Addendum #01 for RFB #914200-01

Project Name: CC Oran Pape Window Repairs

Date: 3/4/2020

Addendum #1:

South Elevation – 2nd Floor East Most Window

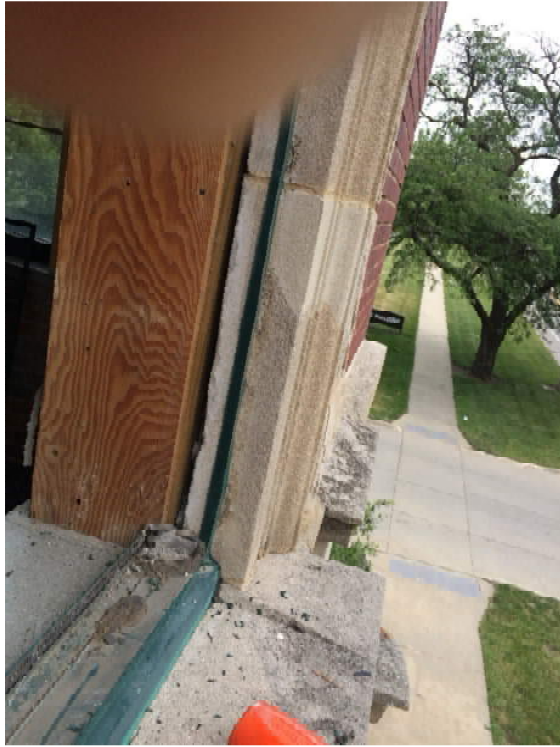
Cosmetic sealant

Daylight showing after primary seal (Exterior) was cut away.

Only one (1) line of caulking.
No secondary seal on interior side
